MONTGOMERY COUNTY HISTORIC PRESERVATION COMMISSION
STAFF REPORT

Address:	3 Primrose Street, Chevy Chase	Meeting Date:	9/22/2021
Resource:	Contributing Resource Chevy Chase Village Historic District	Report Date:	9/15/2021
Applicant:	William Curtin Outerbridge Horsey, Architect	Public Notice:	9/8/2021
Review:	Historic Area Work Permit	Tax Credit:	Partial
Case Number:	951380	Staff:	Dan Bruechert
Proposal:	Accessory Structure Alterations

PROPOSAL

The applicant proposes to replace the existing garage door and install additional garage windows.

GARAGE PLAN AND
ELEVATIONS

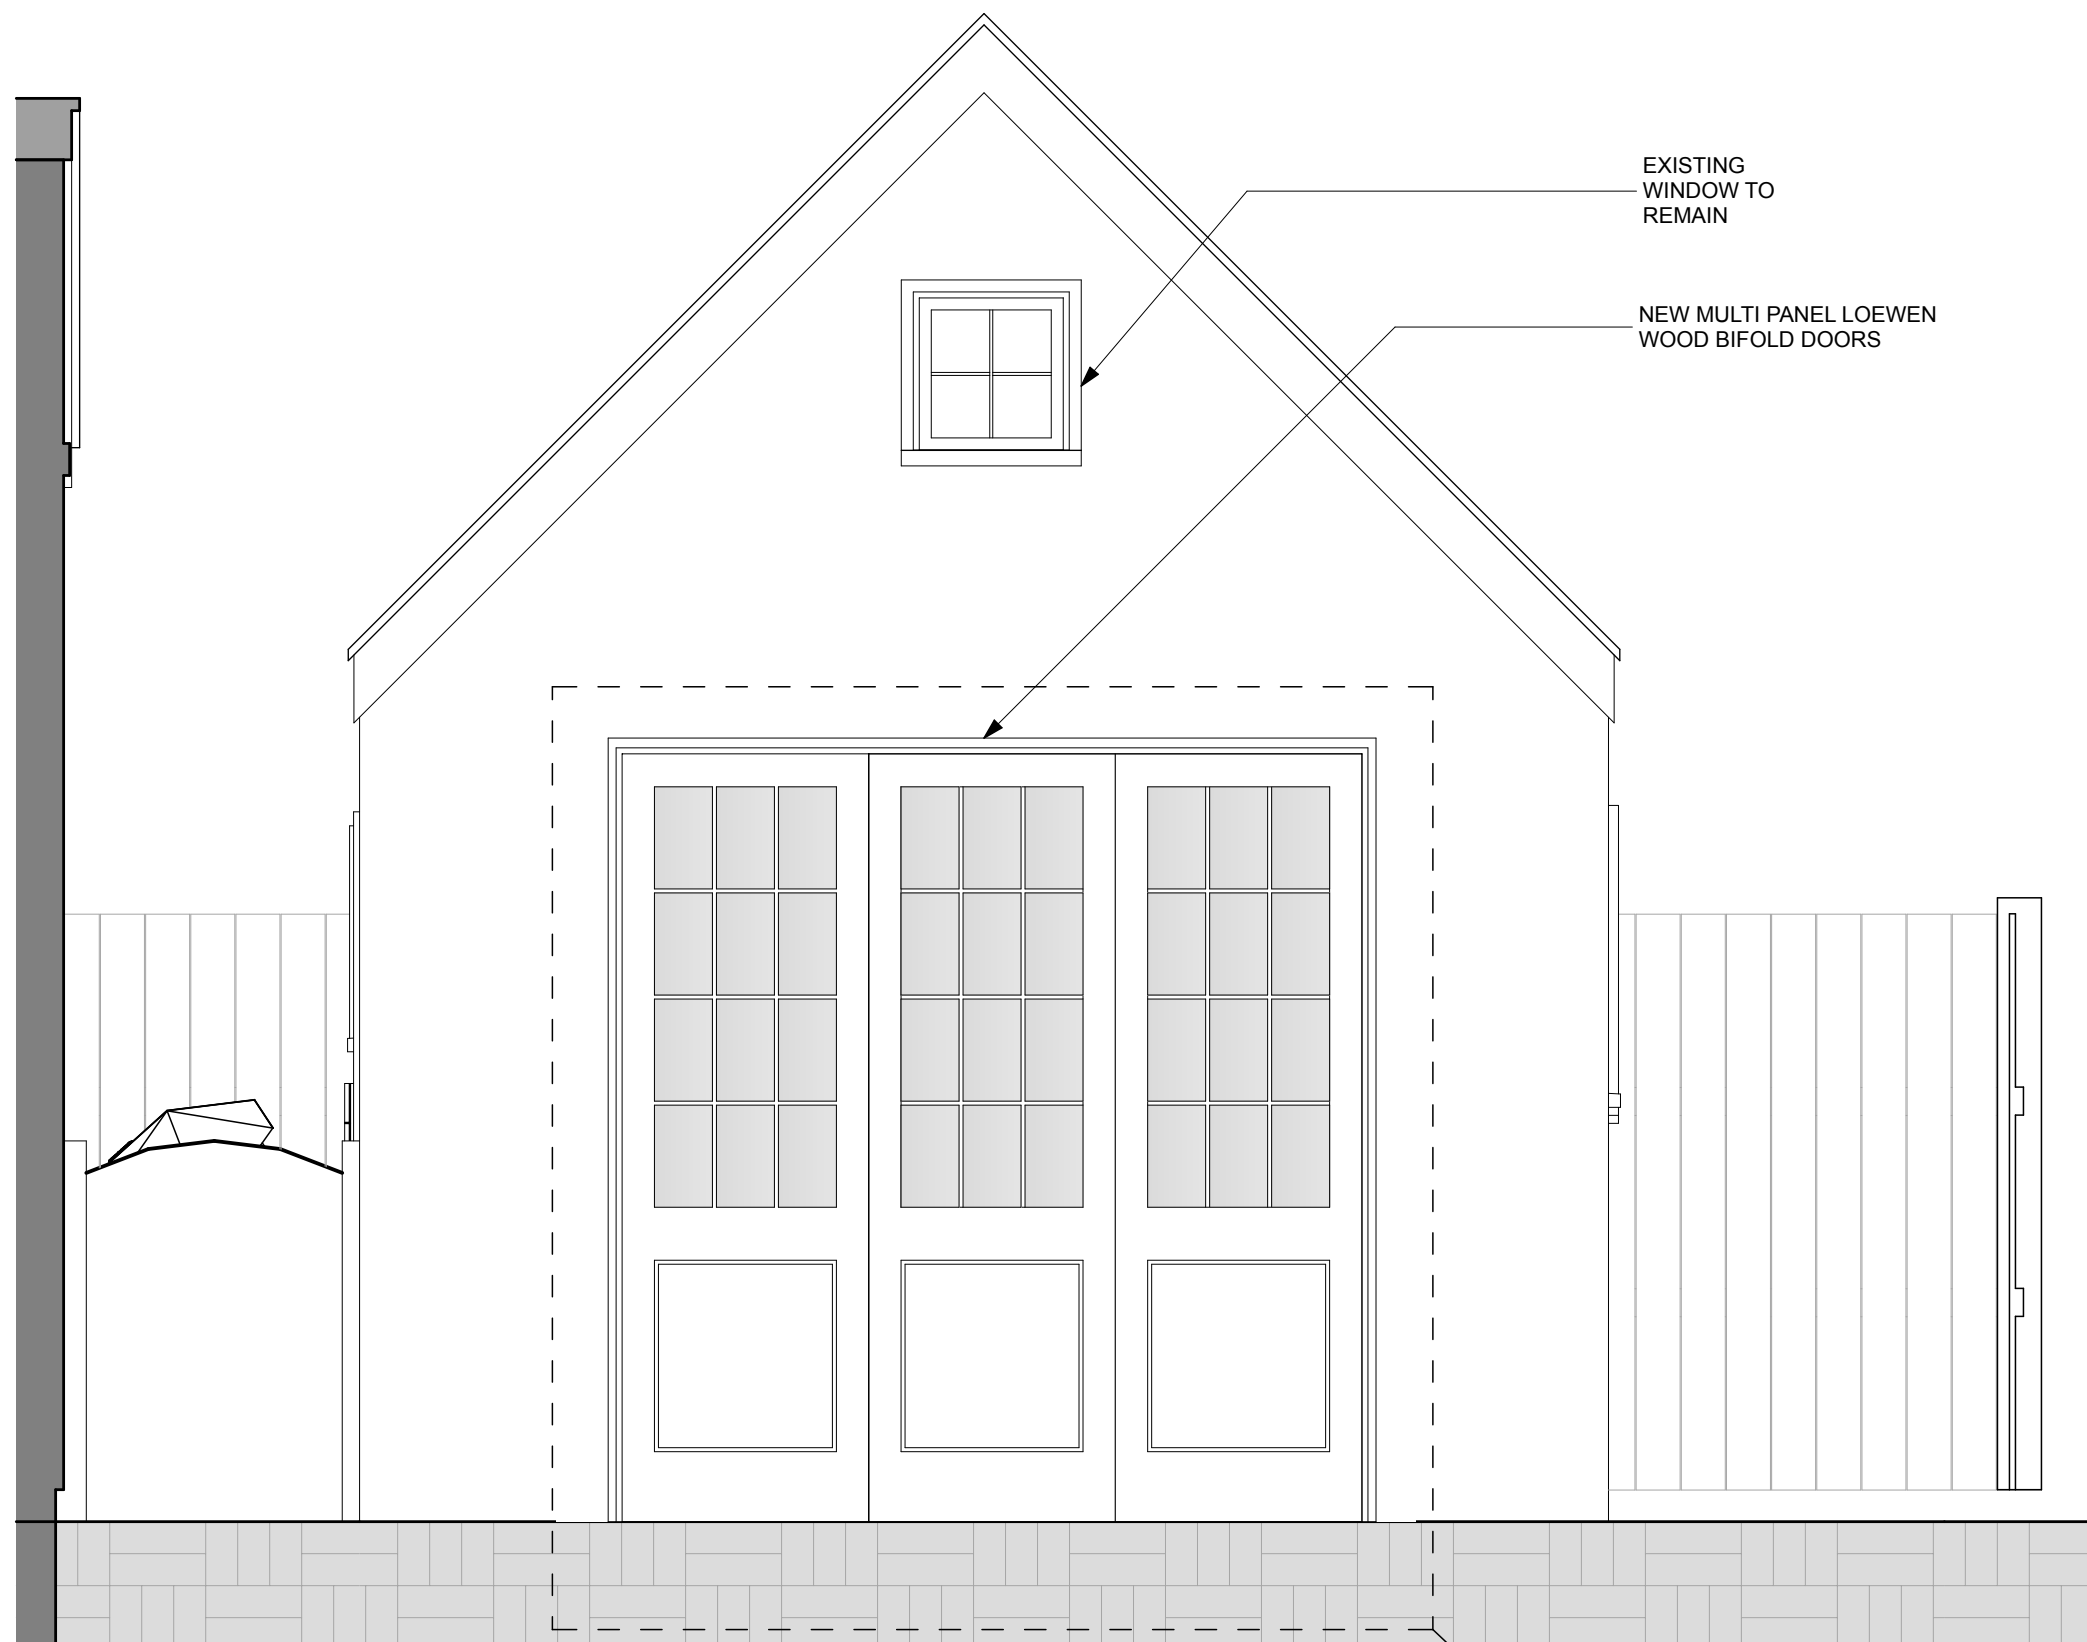
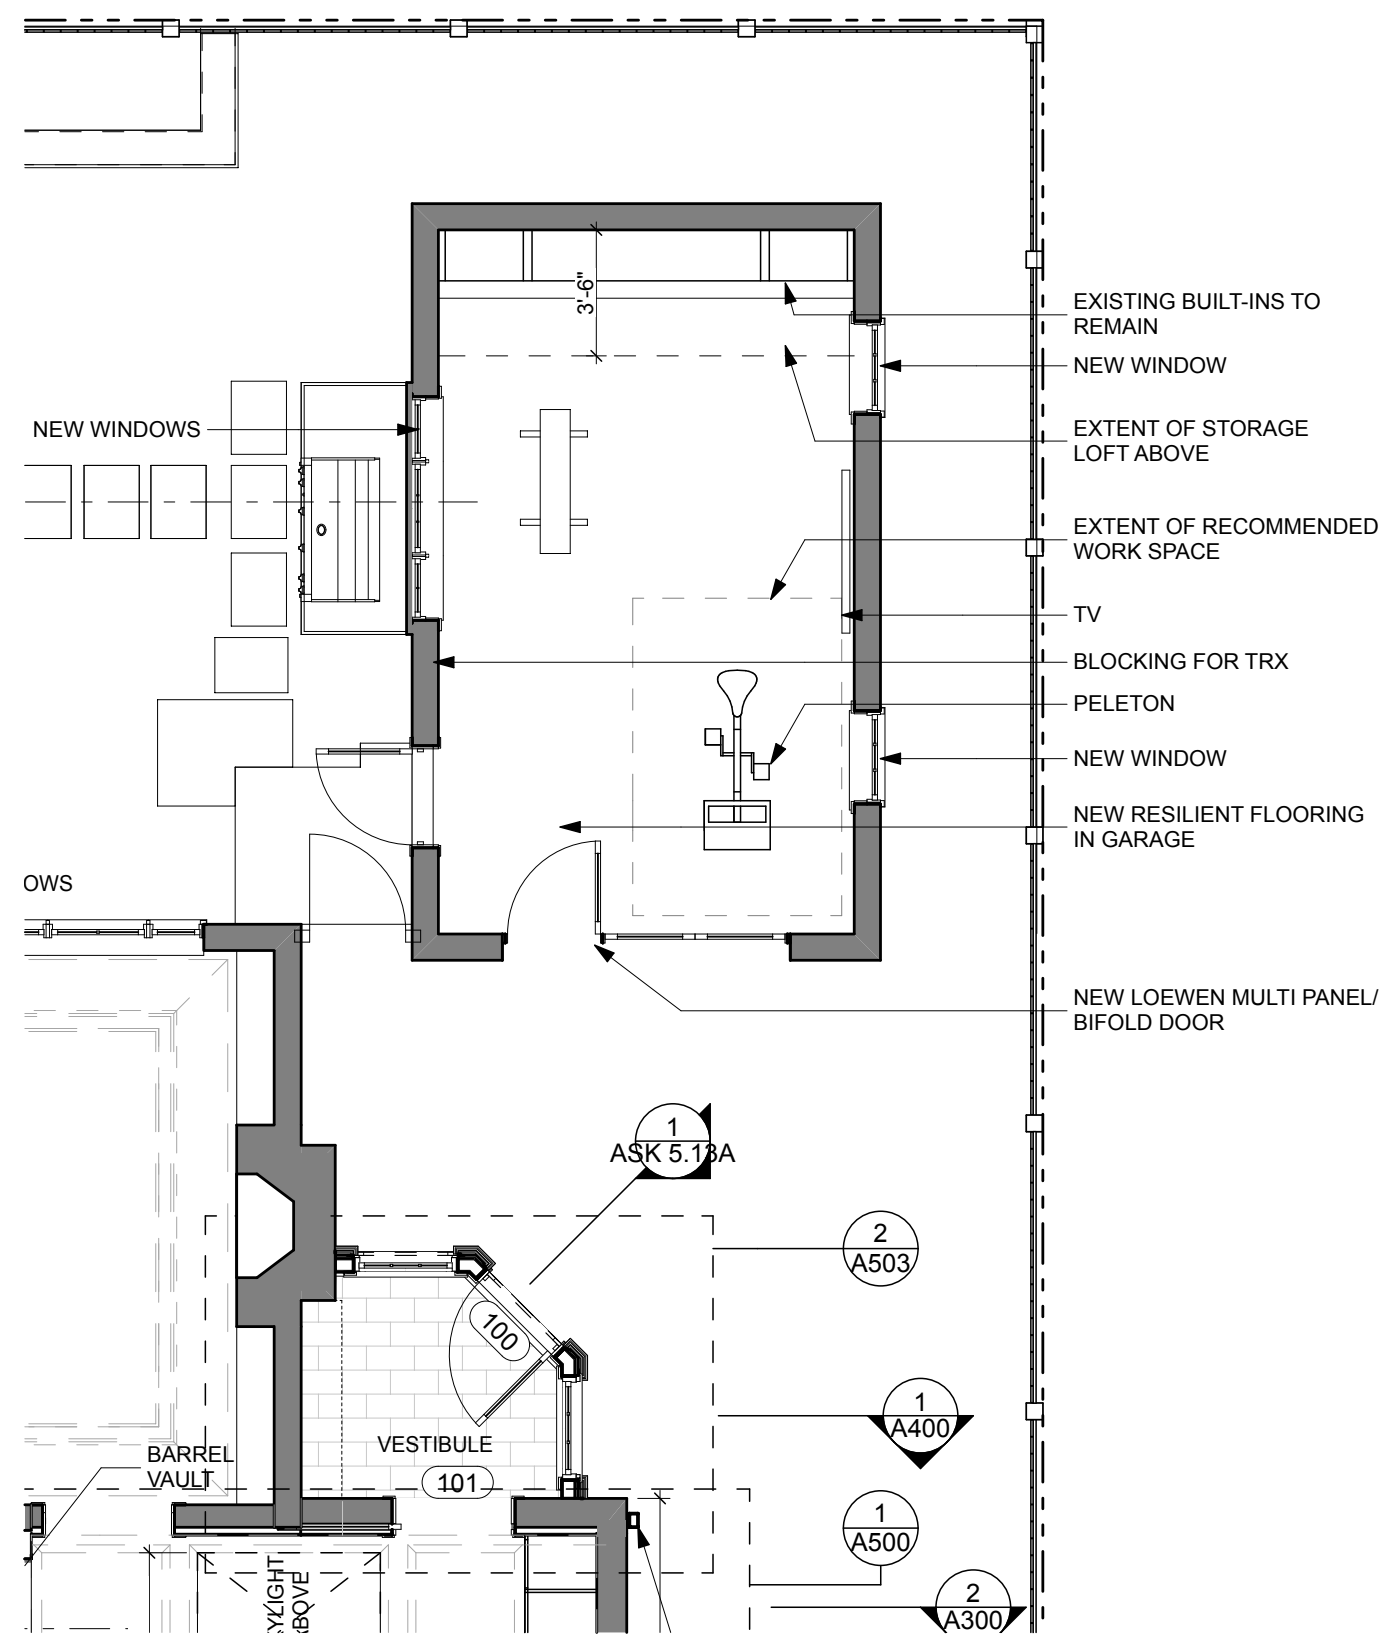
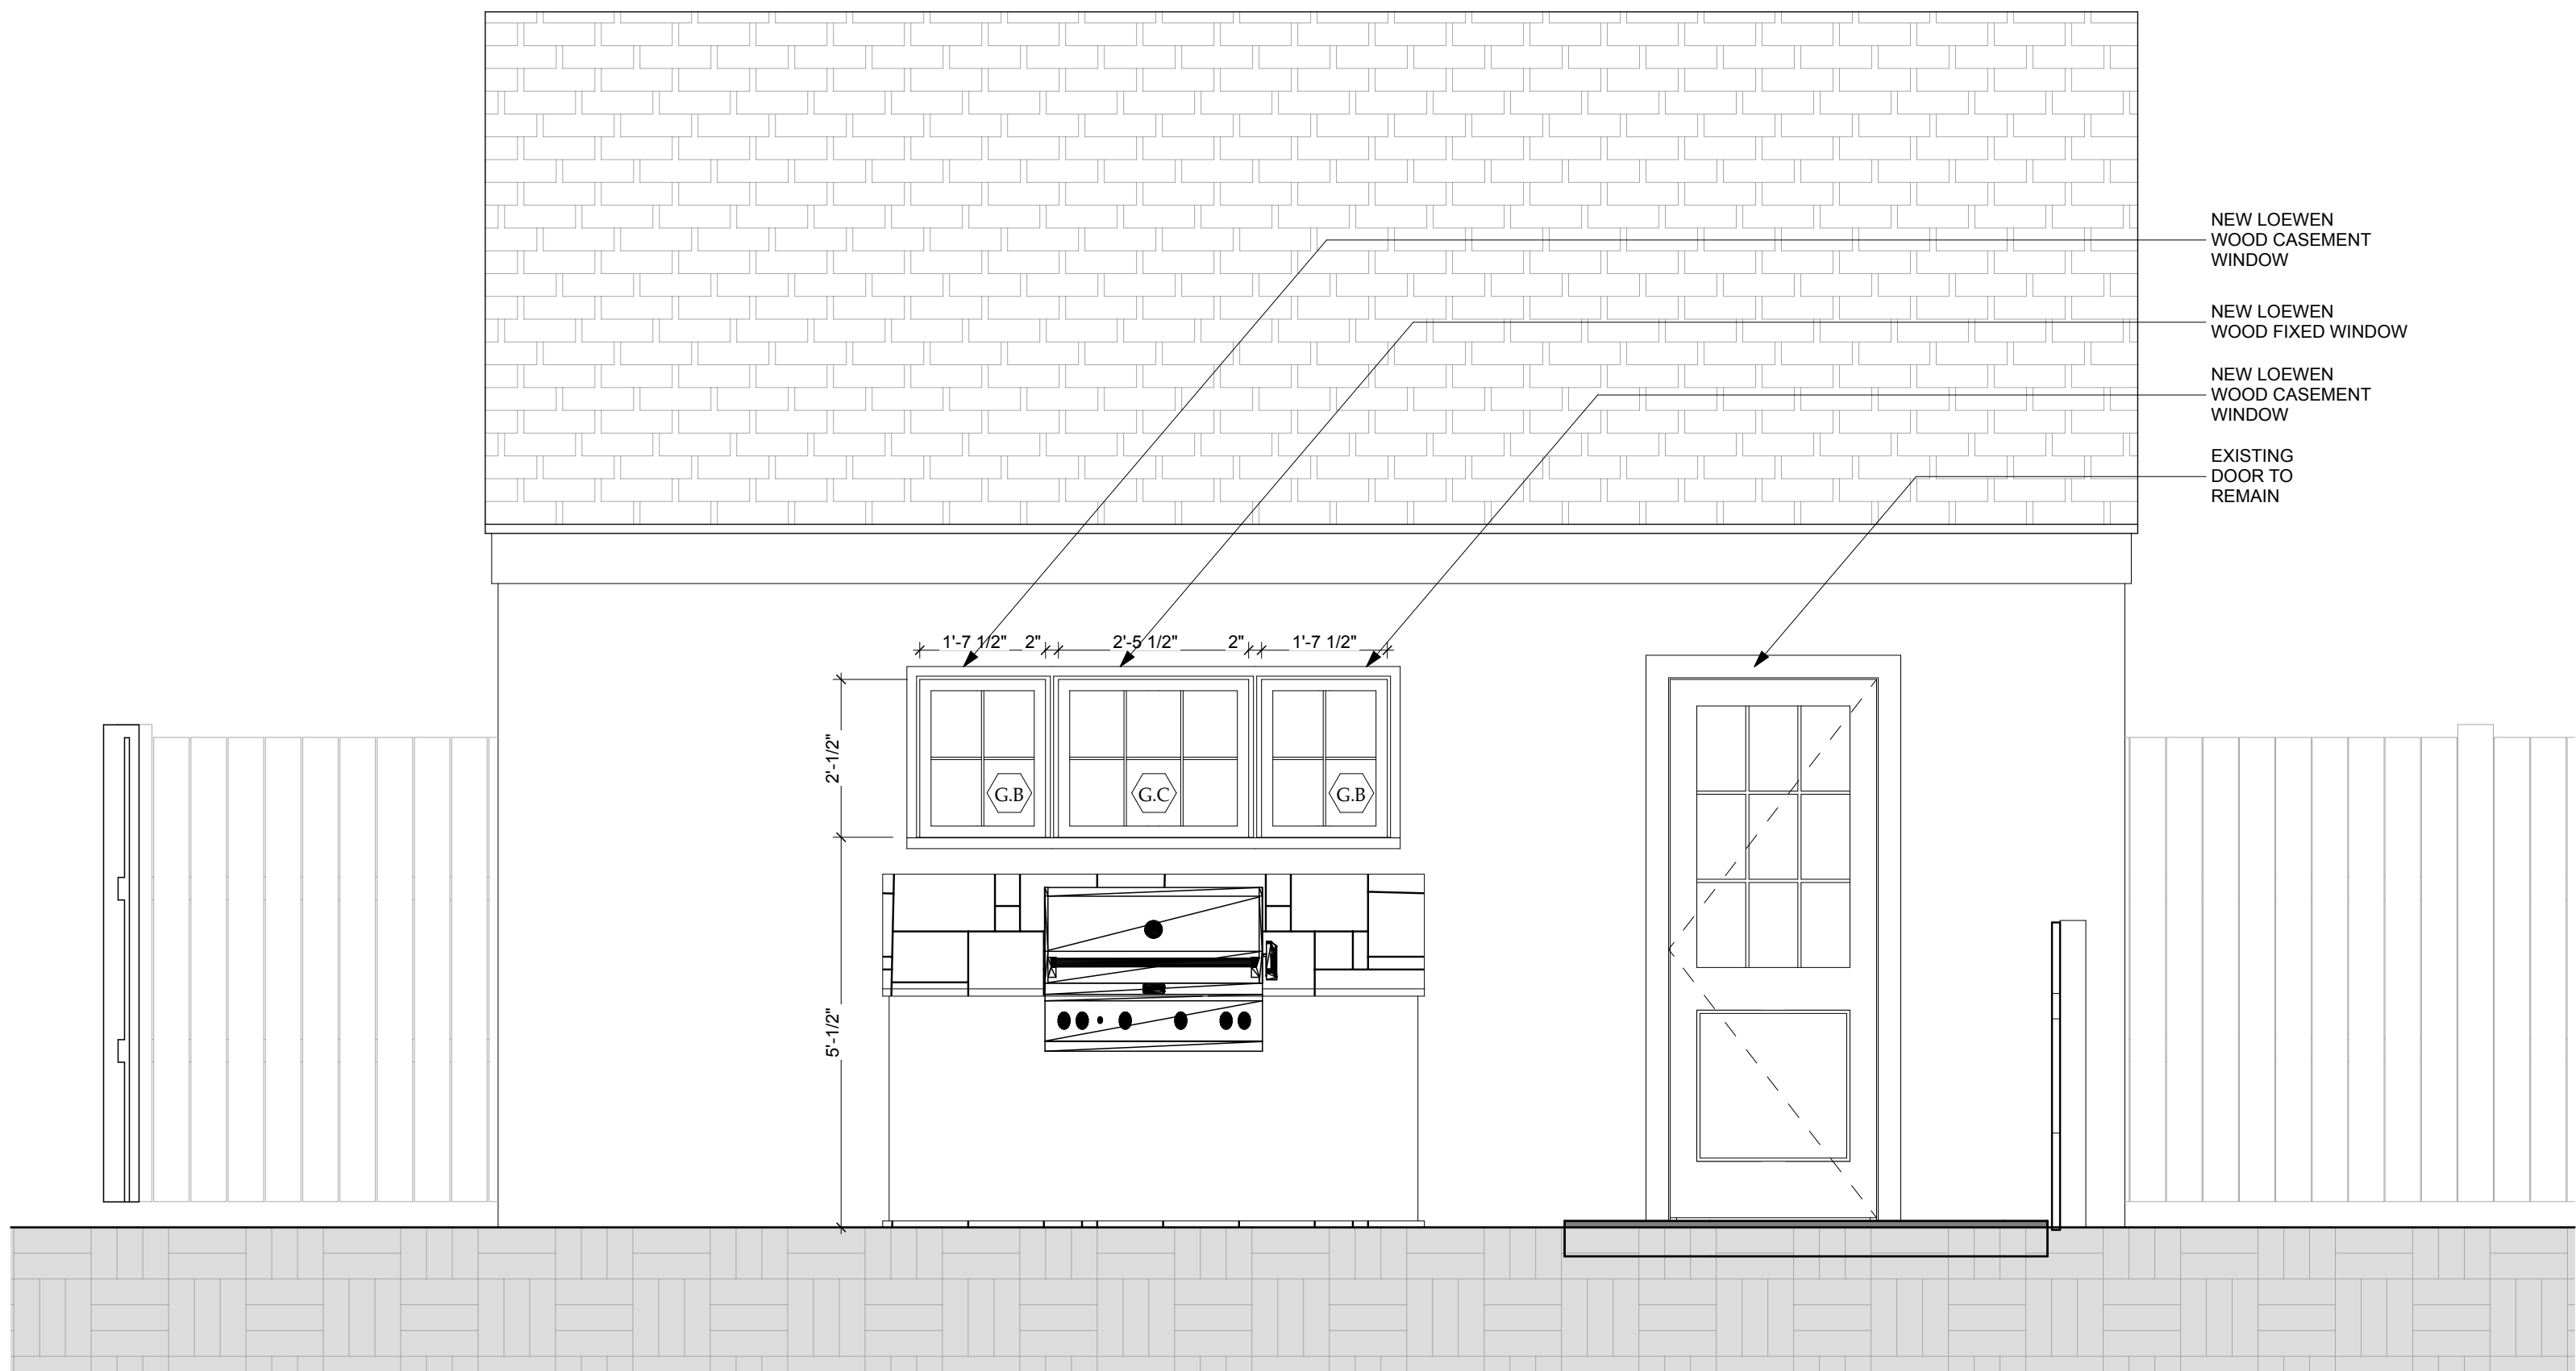
The applicant proposes replacing the existing carriage style, wood garage door with three wood multi-panel bifold doors. The doors have a single panel below the twelve-lite windows. On the left (east) garage elevation, the applicant proposes installing two new window openings and installing wood nine-lite casement windows with sills and trim to match the existing casement window. On the right (west) elevation, the applicant proposes to install a bank of three wood casement windows to the left of the existing side entrance door. These windows will have a sill and trim to match the existing south casement window.

Staff finds that these alterations to the existing, historic, detached garage should all be reviewed under “lenient scrutiny” as defined by the Chevy Chase Village Historic District Design Guidelines. Staff finds that the proposed changes will not impact the size, massing, or streetscape compatibility of the surrounding district and therefore, should be approved under the Design Guidelines. Additionally, Staff finds the proposed windows and doors are compatible with the materials and design of the historic garage and the proposal is consistent with 24A-8(b)(2) and Staff recommends the HPC approve the HAWP.

Staff recommends that the Commission **approve** the HAWP application; under the Criteria for Issuance in Chapter 24A-8(b)(2), and (d), and the *Chevy Chase Village Historic District Guidelines*, having found that the proposal will not substantially alter the exterior features of the historic resource and is compatible in character with the district and the purposes of Chapter 24A;
